# KARREEBOSCH WIND ENERGY FACILITY

PART 2 AMENDMENT OF EXISTING ENVIRONMENTAL AUTHORISATION:  
14/12/16/3/3/2/807/AM3

FINAL AMENDMENT REPORT

Figure 4-1: Position of the 66 Turbines which formed the Original Layout submitted during the EIA phase(source: Savannah Environmental, 2015)

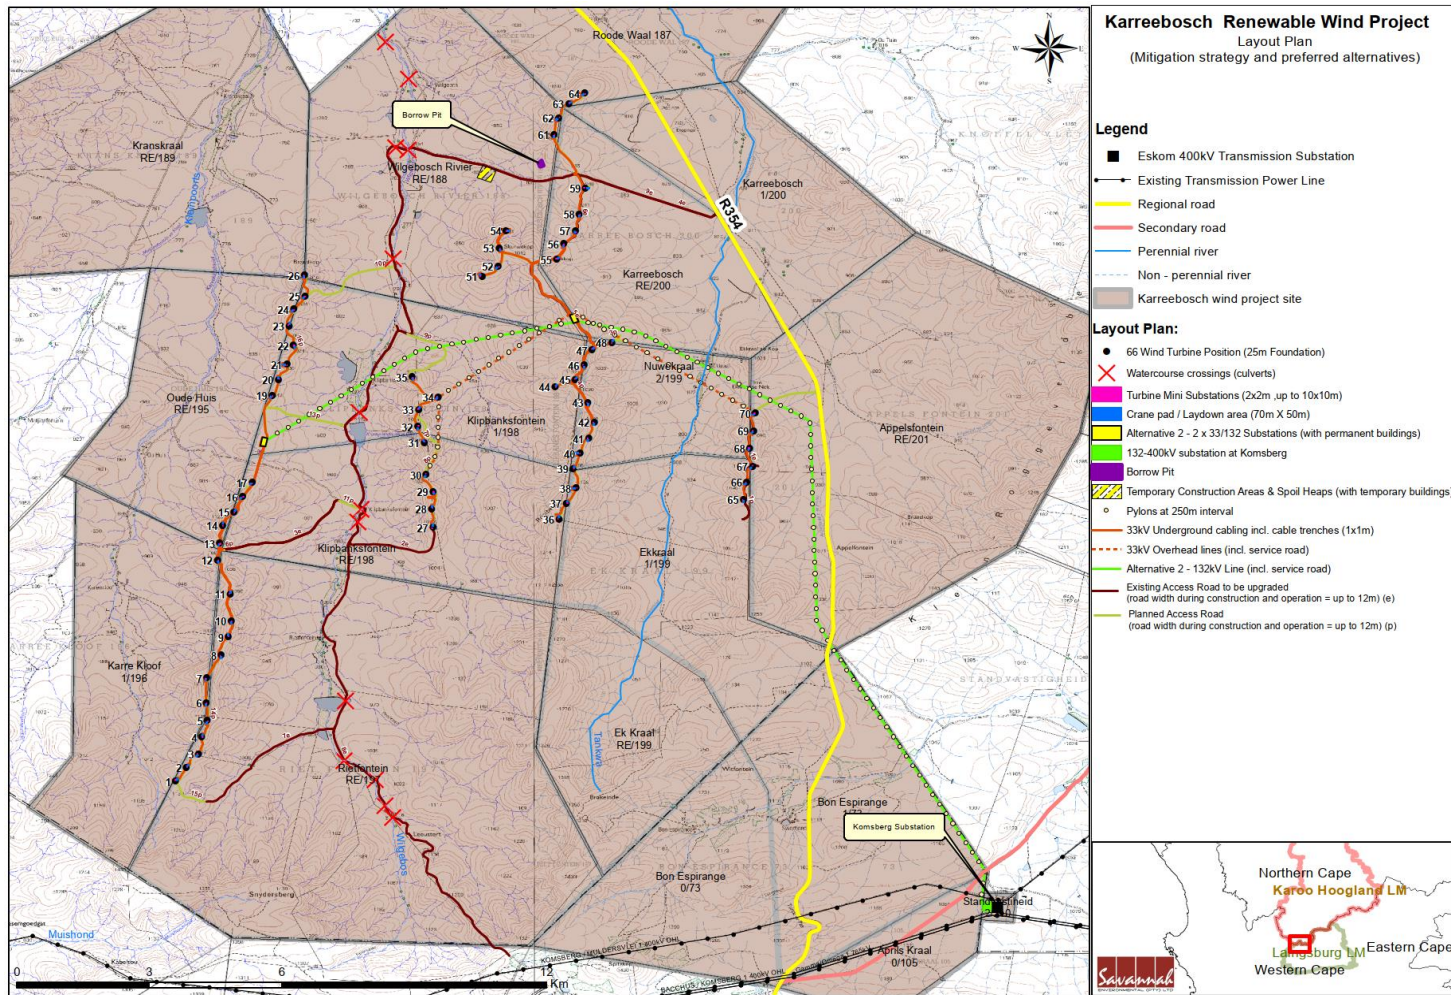
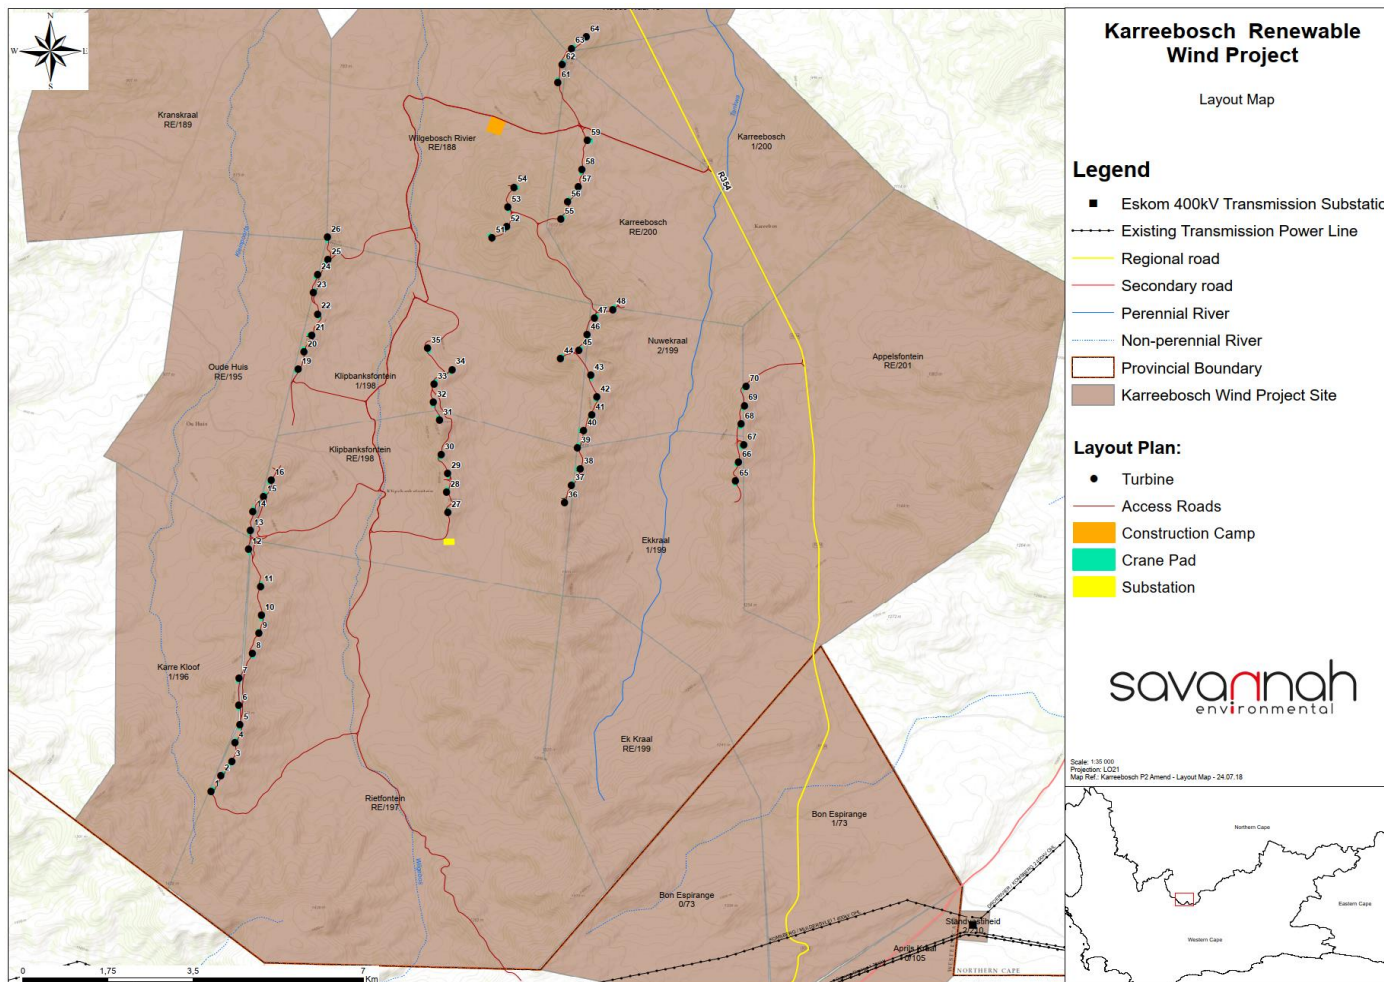
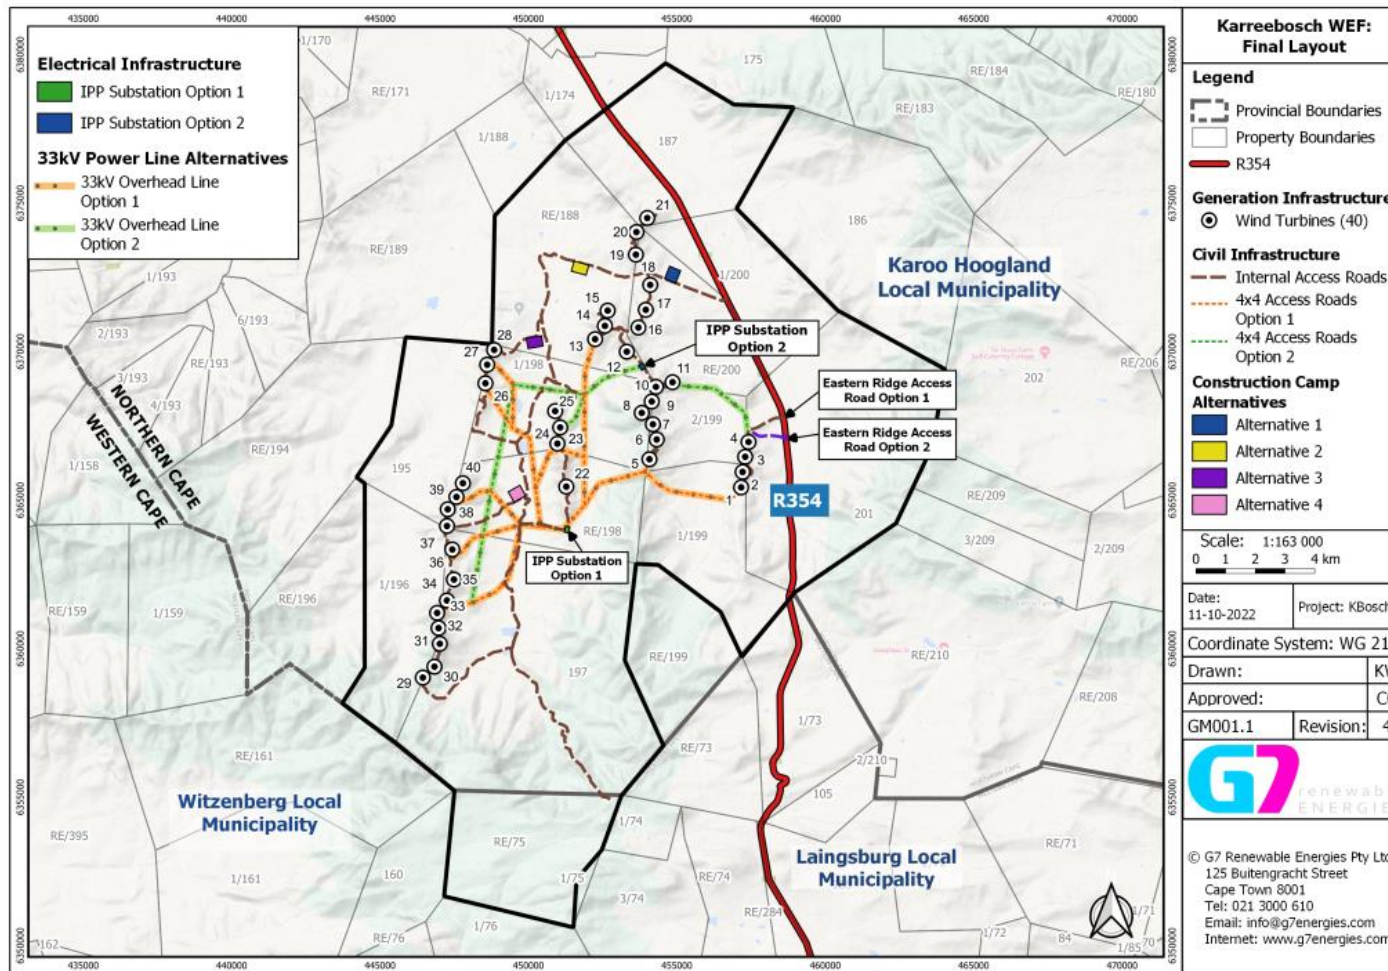
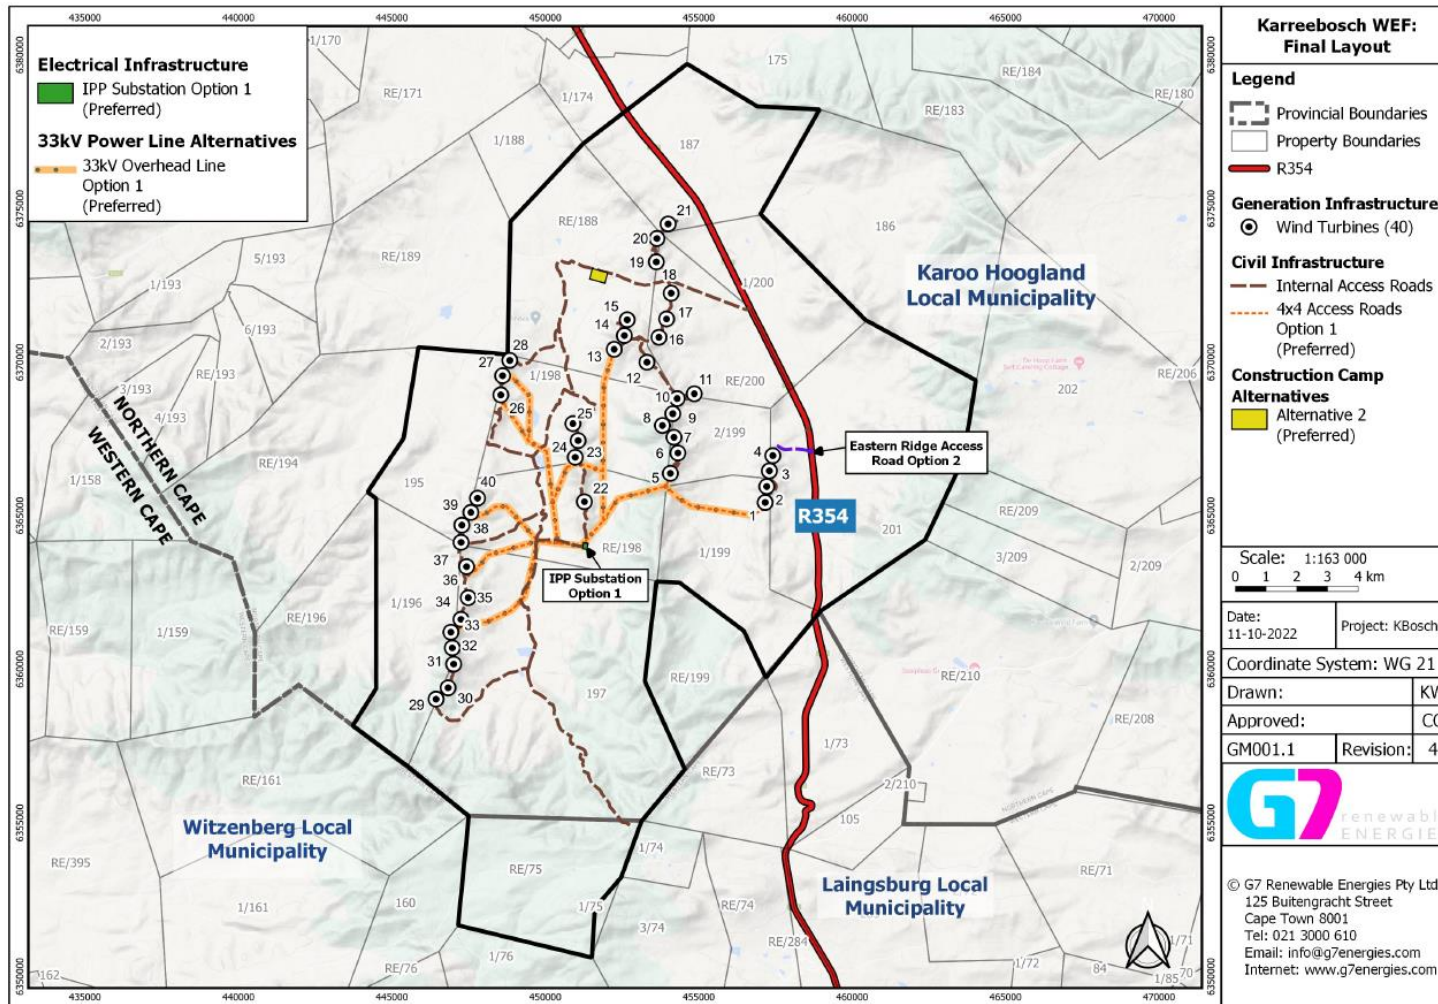
**Figure 4-1** shows the original 66 turbine layout submitted as part of the EIA phase in 2015 and **Figure 4-2** shows the authorised 65 turbine layout relevant to the EA authorised in January 2016 which includes the removal of turbine 17 and subsequent November 2018 EA Amendment. **Figure 4-3** illustrates the proposed 40-turbine layout subject to this Part EA amendment, final layout and EMP approval process. **Figure 4-4** illustrates the final layout for approval as an outcome of the specialist assessments and walkdowns.

<sup>4</sup> The original Turbine 17 location (shown in Figure 4-1 of this report) has been removed from the Final Layout (Figure 4-4).

**Figure 4-4: Final Layout for approval, showing the RE 40 turbine positions for the Karreebosch WEF (Source: G7 Renewable Energies (Pty) Ltd, 2022)**

**Figure 5-3: Bat sensitivity map in relation to the proposed turbine layout. Shaded red = high bat sensitivity; Red line = 250m High bat sensitivity buffer; Shaded yellow = Moderate bat sensitivity; Yellow line = moderate bat sensitivity buffer (Insert – close up of Turbine 17) (Animalia, 2022).**

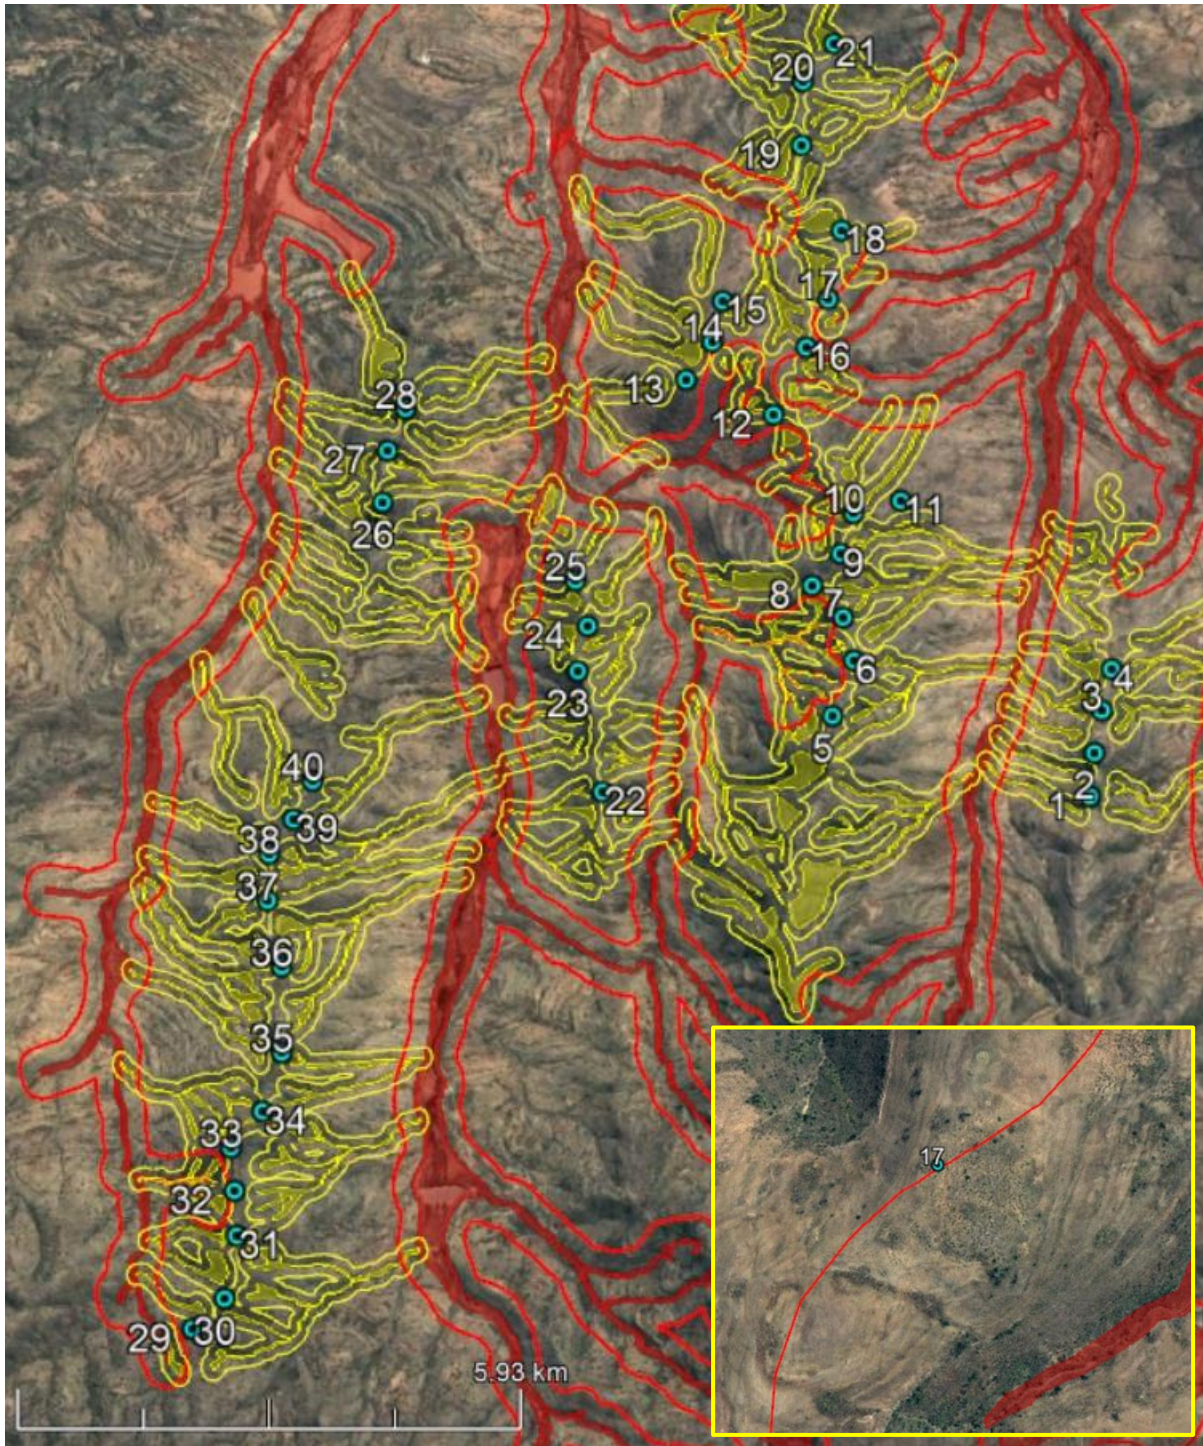
Turbine 17 has been identified to have a proposed foundation position of 250m from a high bat sensitivity (as per Figure 5-3), which means that a blade overhang of 35m will be present if a minimum high sensitivity buffer of 200m is considered. However, when applying the spatial formula described in Section 3, and considering an elevation difference of 20m between the turbine base point and the high bat sensitivity, this turbine base point must be at least 235.8m from the high bat sensitivity (on a two-dimensional map plane) to allow for the blade tip to be 200m from the high bat sensitivity. Currently the turbine base point is 250m from the sensitivity, and therefore no further amendment is required to the location of Turbine 17 and it is considered acceptable.

**Figure 7-1: Final Layout for approval, showing the 40 turbine positions for the Karreebosch WEF (Source: G7 Renewable Energies (Pty) Ltd, 2022)**

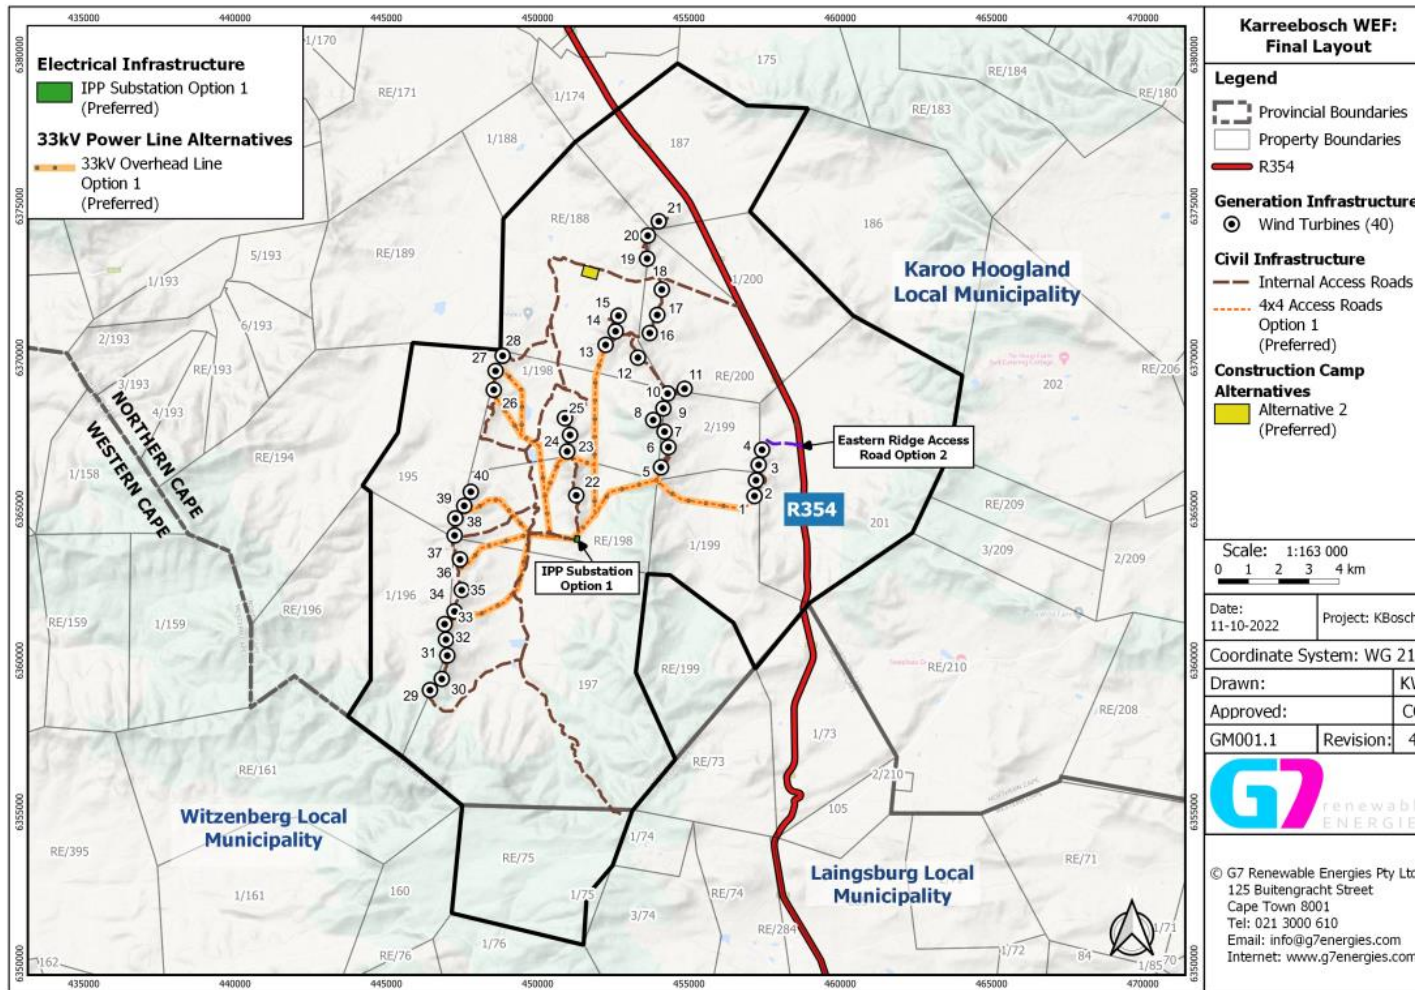
Based on the findings of the specialists, the EAP recommends that DFFE amends the EA as requested in **Table 4-1**, and the DFFE approves the Amended Final EMPr (**Appendix Q**) and final layout map (**Figure 7-1**).
